# Merton Council Planning Applications Committee 9 February 2023 Supplementary agenda

#### **Modifications Sheet.**

#### ITEM 5 – 19 ARRAS AVENUE, MORDEN, SM4 6DG

PART SINGLE /PART TWO STOREY SIDE AND REAR EXTENSIONS, ROOF EXTENSIONS AND CONVERSION OF PROPERTY INTO 6 SELF-CONTAINED FLATS (2 X 3-BED, 1 X 2-BED, 3 X 1-BED/1-PERSON) WITH ASSOCIATED OUTSIDE AMBENTY SPACE AND REFUSE AND BICYCLE ENCLOSURES

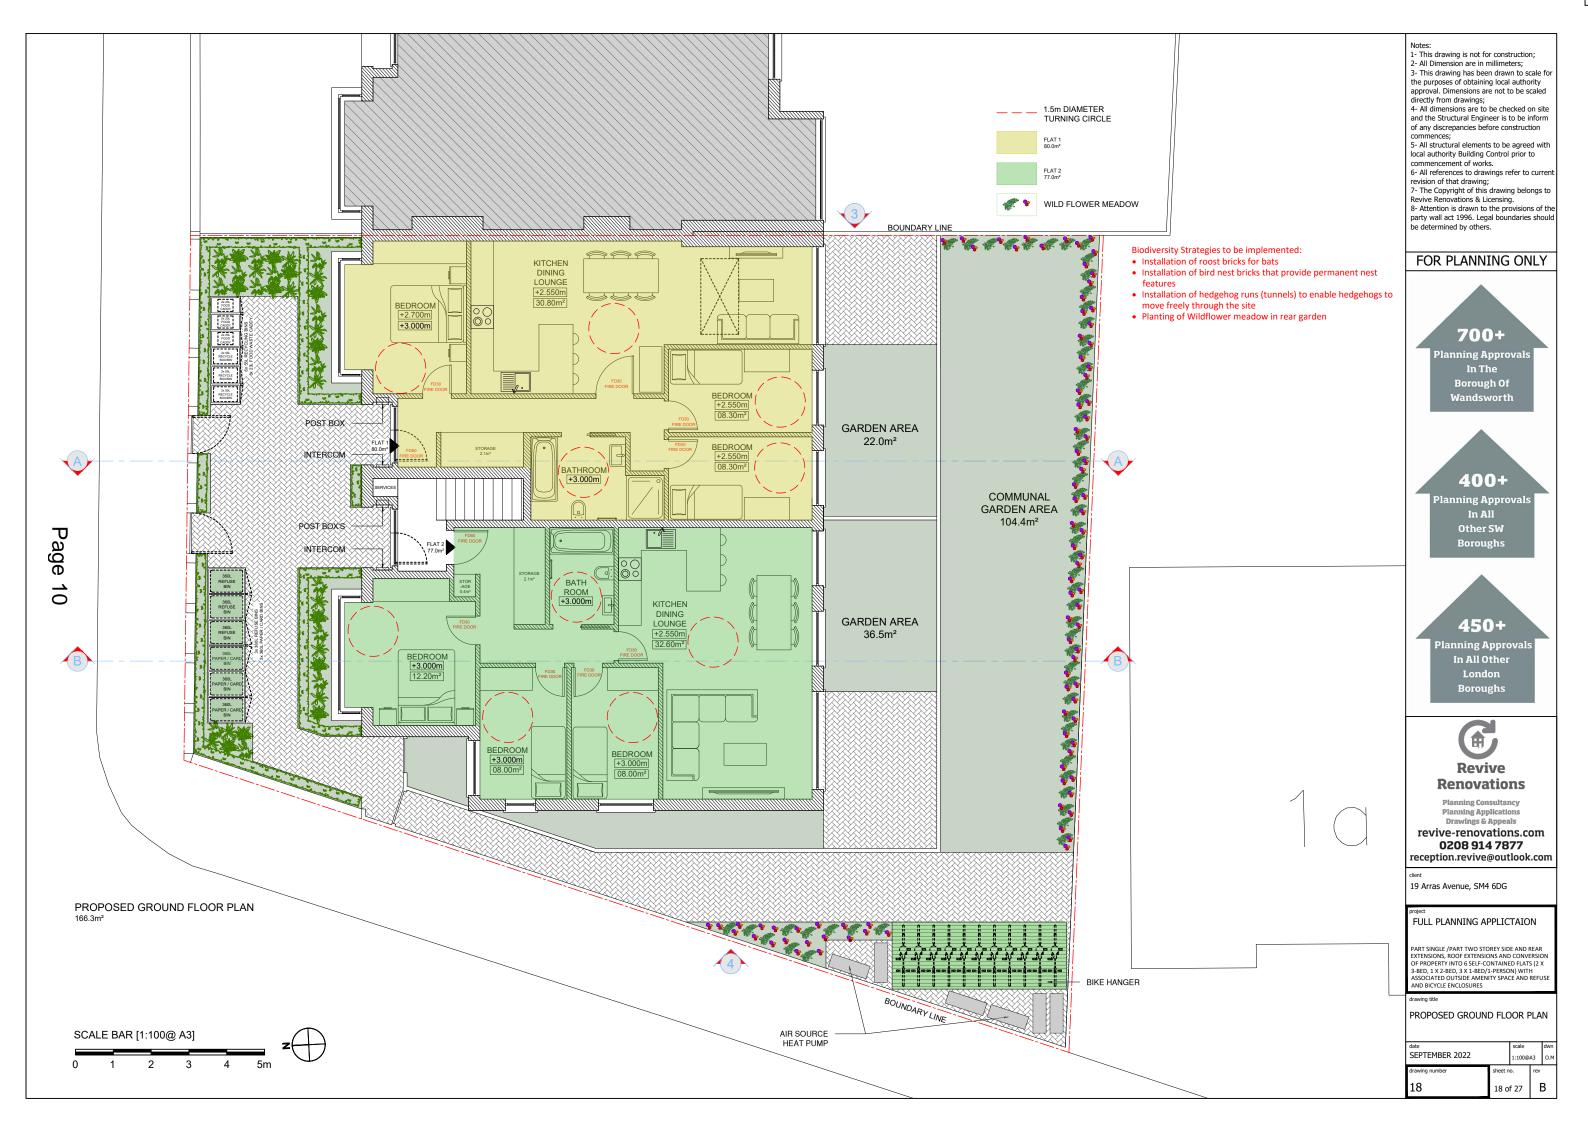
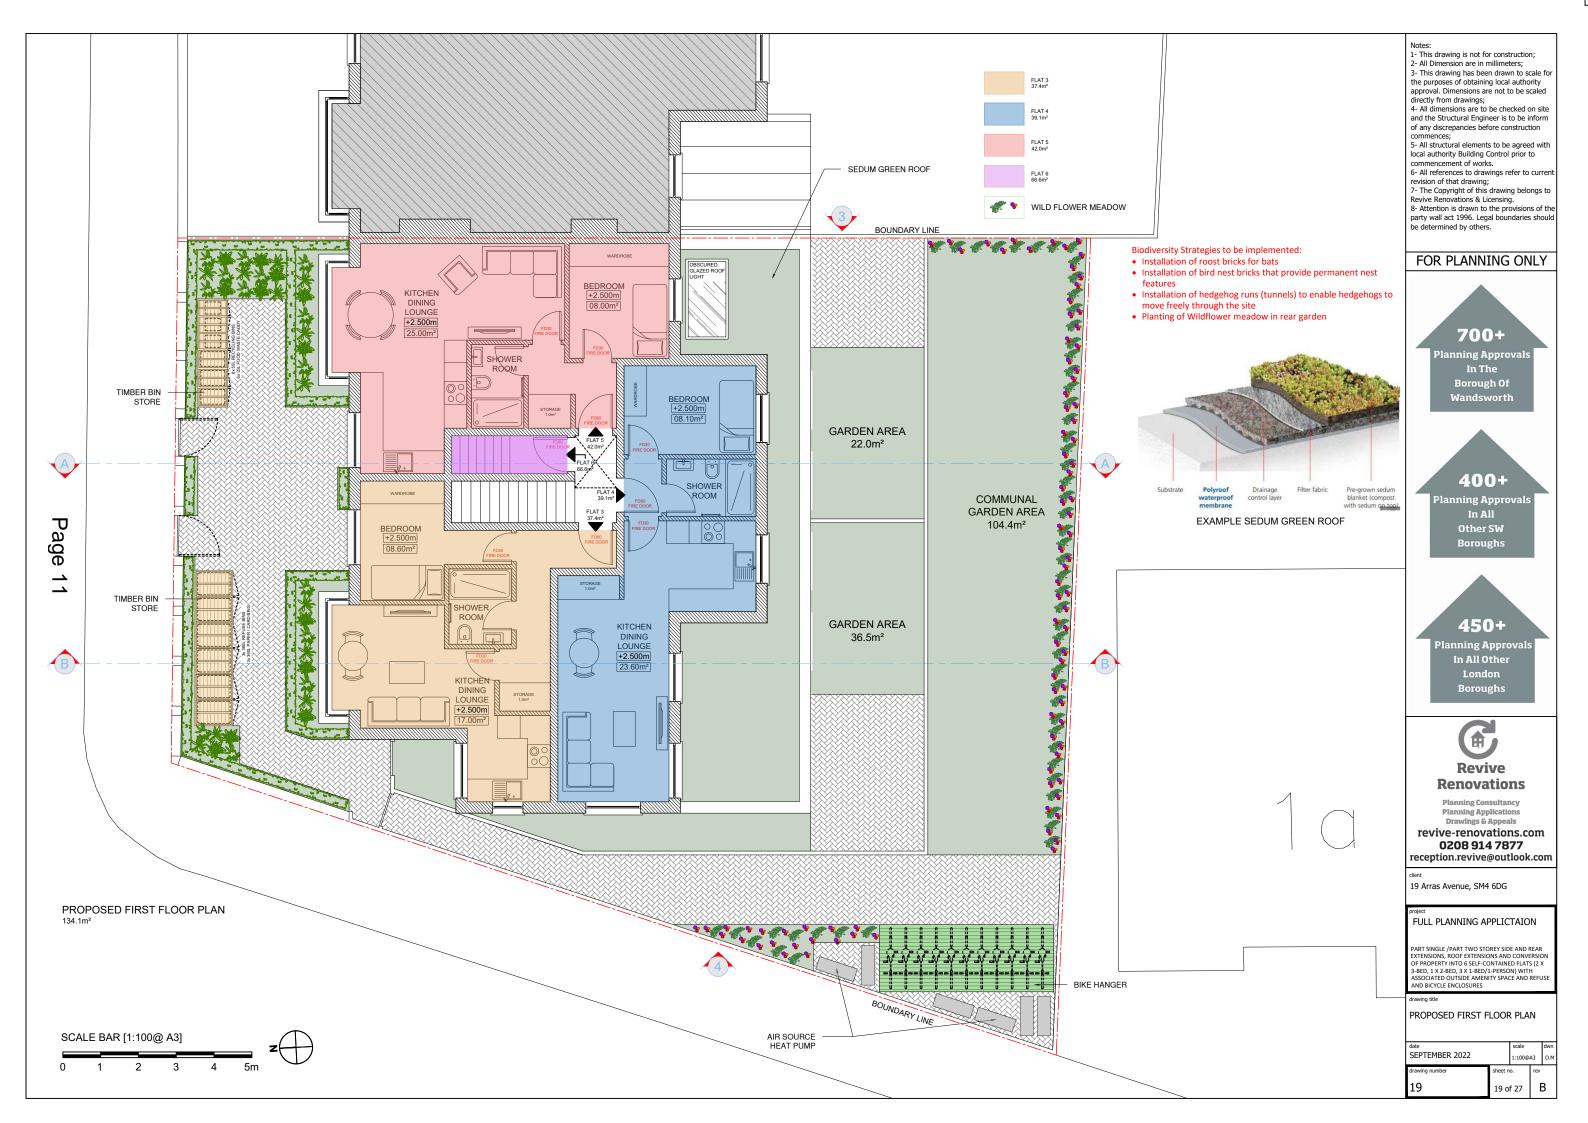
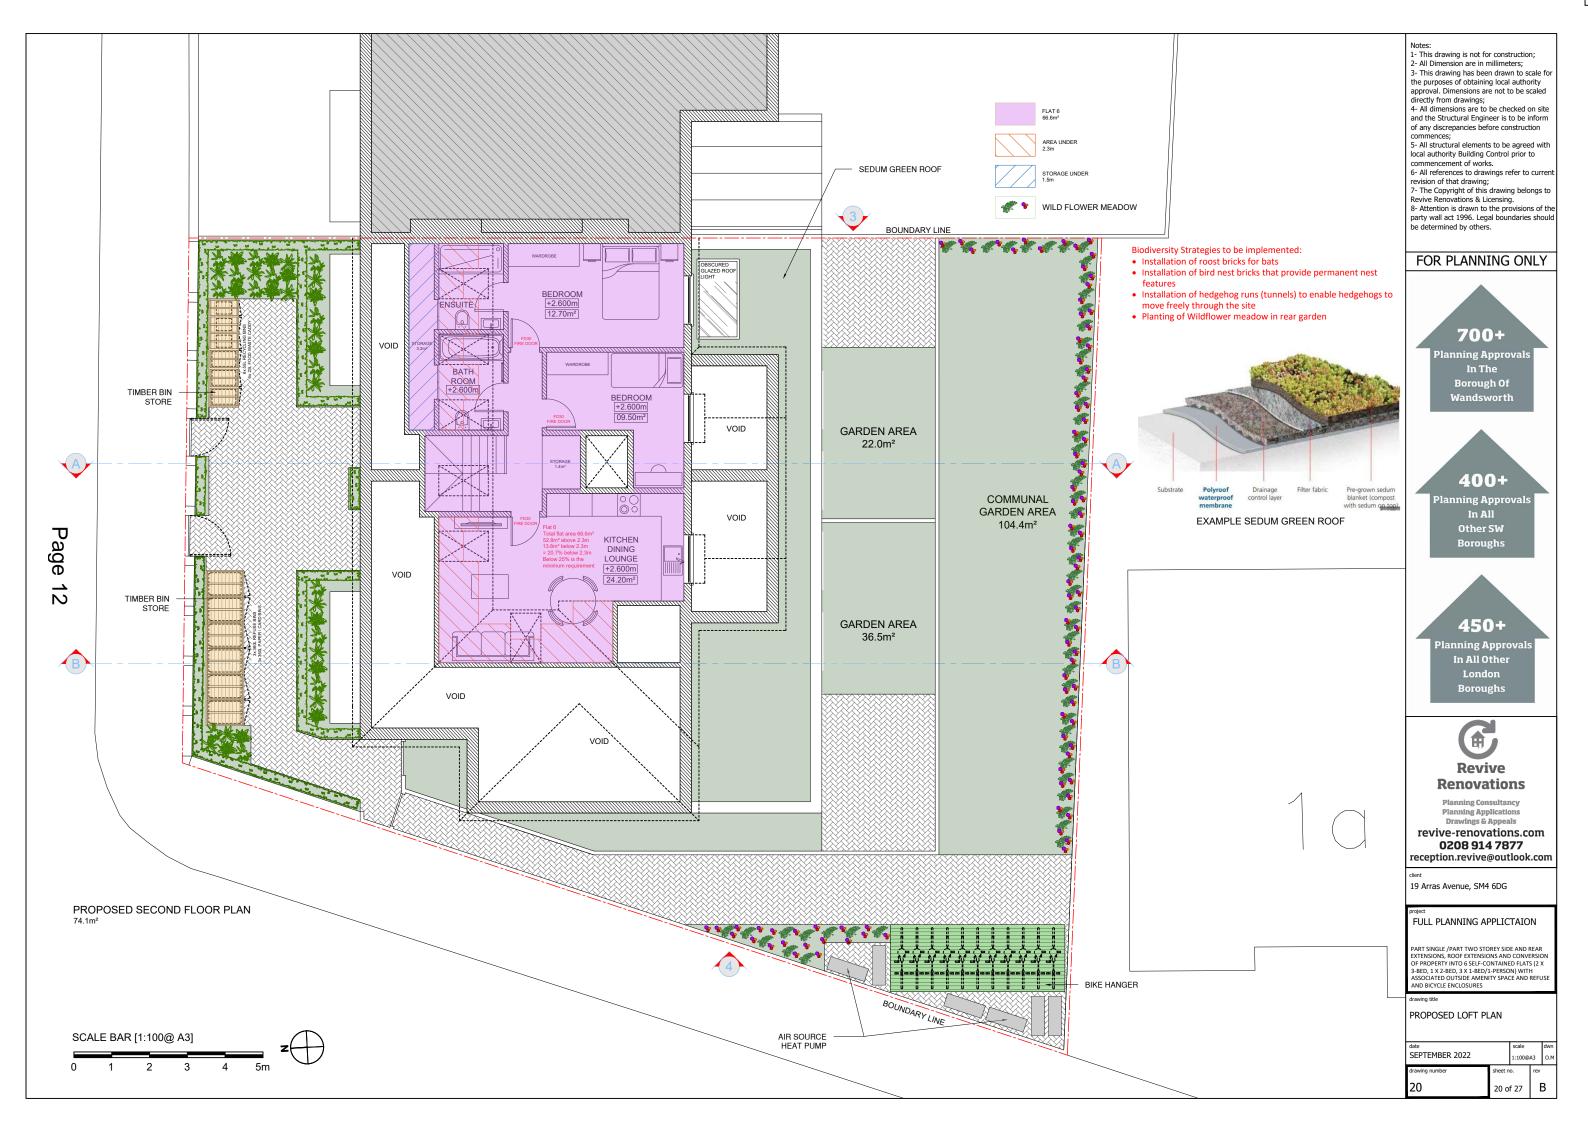
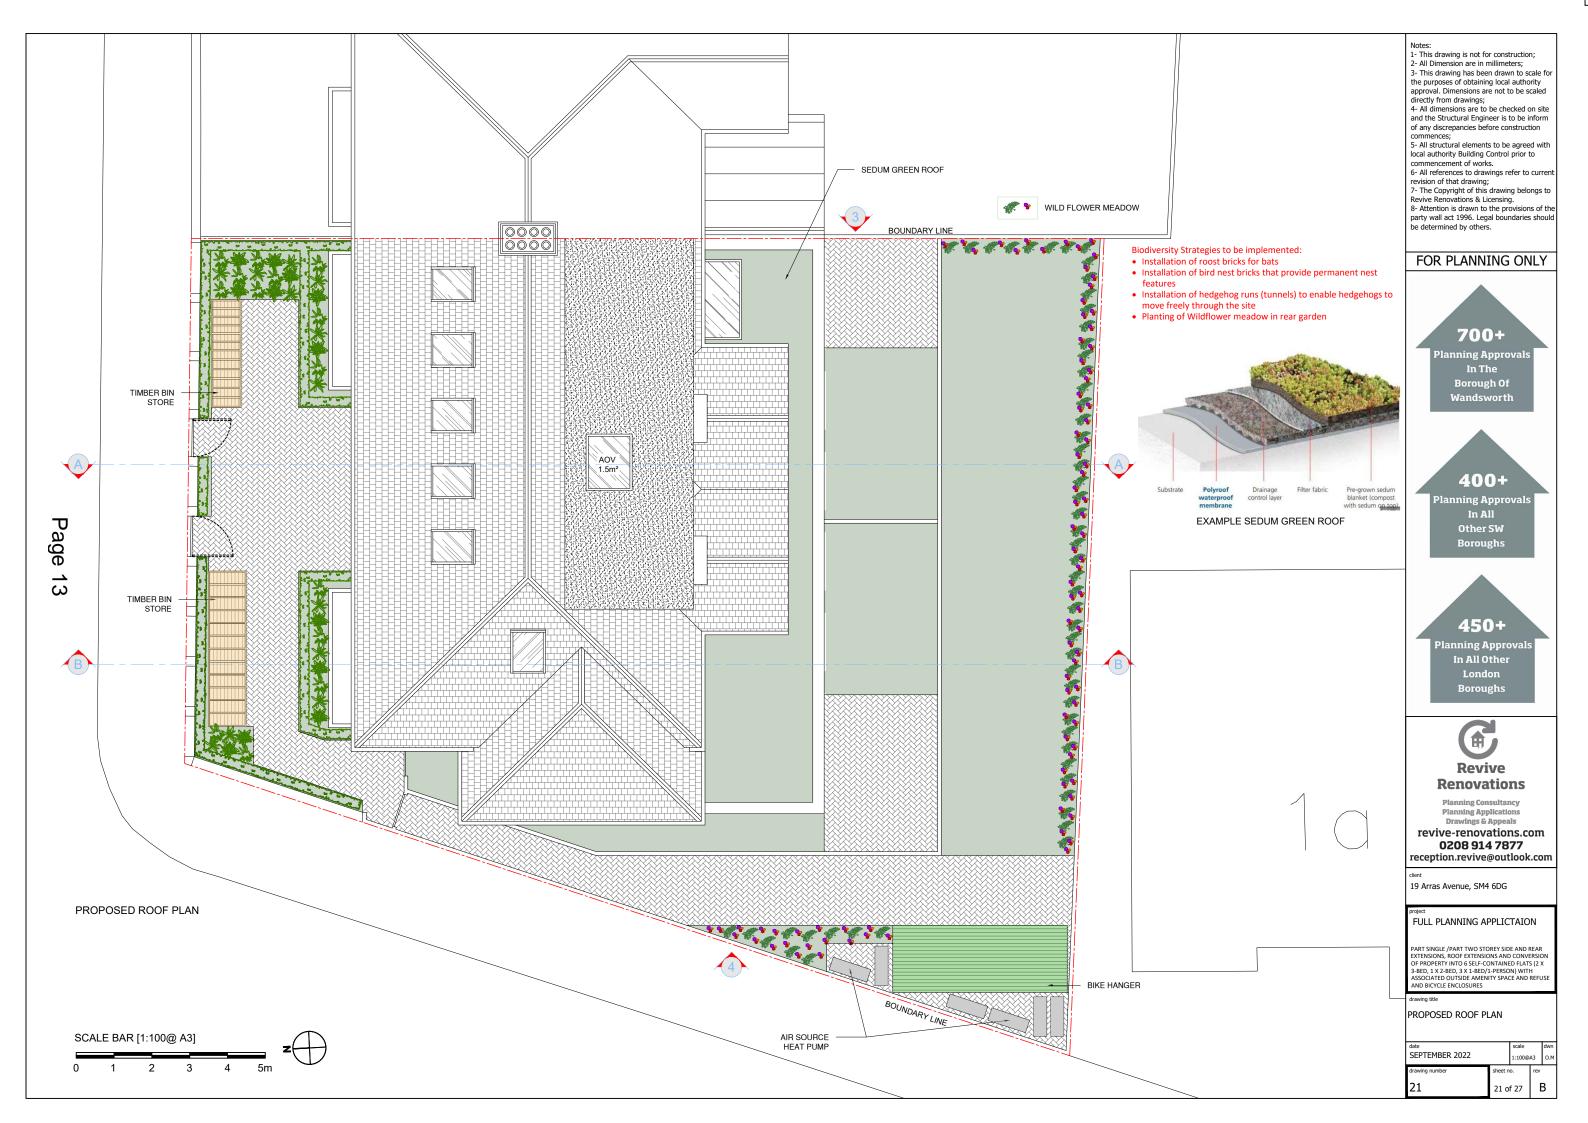
# Q - Waste storage - members enquired as to whether larger communal eurobins could be used?

A - Waste Services were consulted and provided that, in line with Waste and Recycling Storage Requirements: A Guidance Note for Architects, eurobins should only be used for developments with 10 or more units. Shared 360L was recommended instead to minimise storage space.

'The use of communal shared/ euro bins are only permissible for blocks of flats with 10x units and above. Based on the unique circumstances, 9x units can be considered as an exception only and this is jointly agreed by all concerned.

The proposed development with 6x units would be considered under the fortnightly shared wheelie bin service and other individual waste bins.
